**ZONING AMENDMENT,
& SUBDIVISION STAFF REPORT****Date: September 20, 2007****APPLICANT NAME**

Ramshead, LLC

Ramshead Commercial Park Subdivision

SITE PLAN

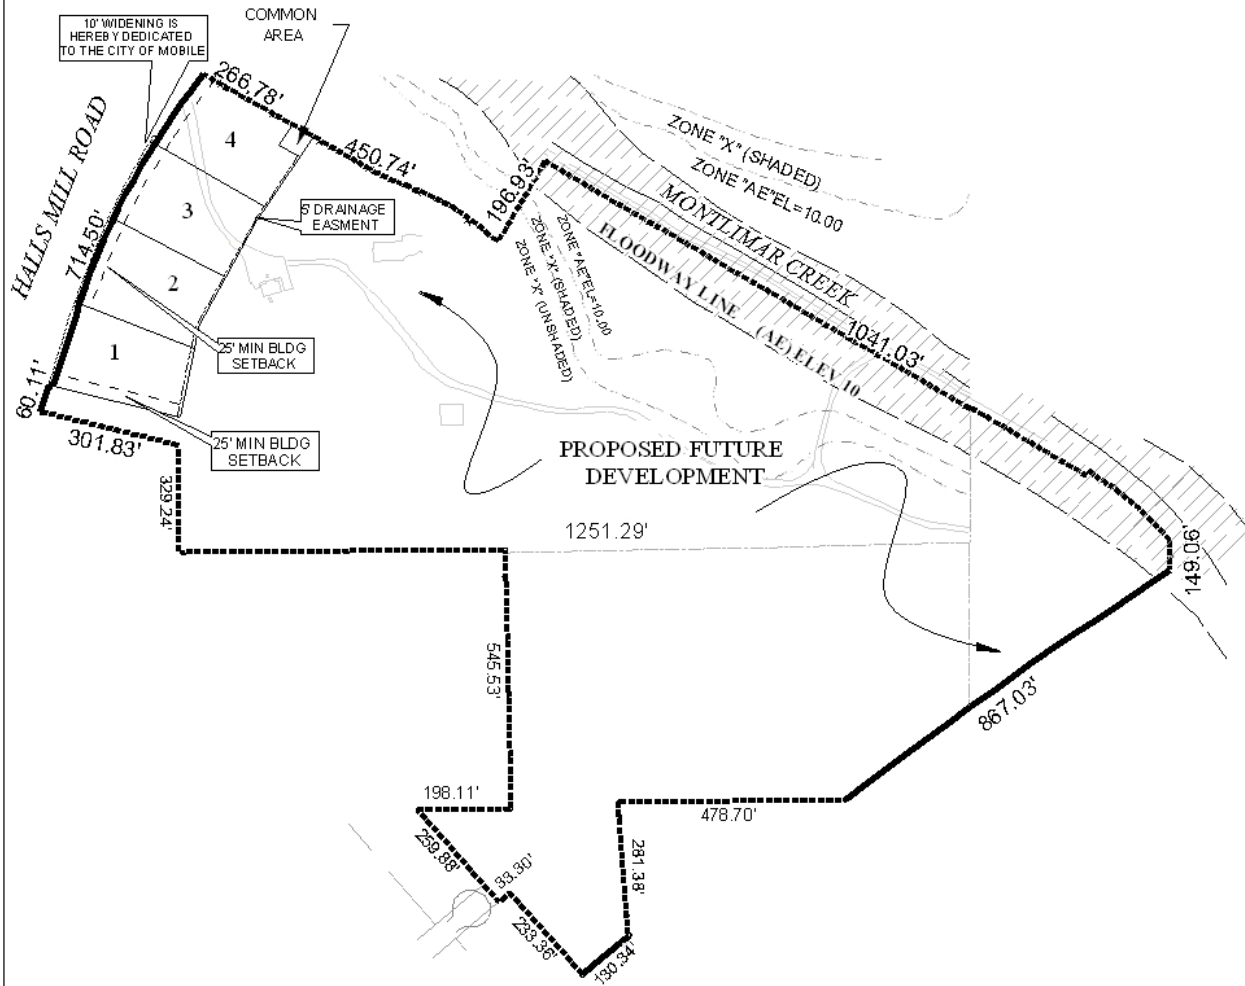
The site fronts onto Halls Mill Road, a collector street, which currently has a 60' right-of-way in this area. As a collector street, the right-of-way should be a minimum of 70' wide, thus dedication of sufficient right-of-way to provide 35' as measured from the centerline of Halls Mill Road should be required. The plat indicates a 10' dedication for right-of-way, although 5' would be sufficient. The plat did not indicate a minimum building setback line. The minimum building setback line should be indicated on the final plat as being measured from the new right-of-way line, after dedication.

As shown on the plat, each lot has less than 200 linear feet of street frontage; therefore each lot should be limited to one curb cut with the location, size, and design to be approved by Traffic Engineering and conform to AASHTO standards.

The plat labels each lot with its size in acres and square feet. Each lot should be labeled on the final plat with its size in square feet, or a table provided depicting the same information.

A common area is proposed for the subdivision. A note should be placed on the Final Plat, if approved, stating that maintenance of the common area is the responsibility of the subdivision's property owners.

- 1) dedication of sufficient right-of-way to provide 35' as measured from the centerline of Halls Mill Road;

- 2) depiction of the 25' minimum building setback line as measured from the new right-of-way line after dedication;
- 3) placement of a note on the final plat stating that each lot is limited to one curb cut to Halls Mill Road, with the size, location, and design of all curb cuts to be approved by Traffic Engineering and conform to AASHTO standards;

- 4) the labeling of each lot with its size in square feet, or placement of a table on the plat with the same information;
- 5) placement of a note on the final plat stating that the maintenance of the common area is the responsibility of the property owners;
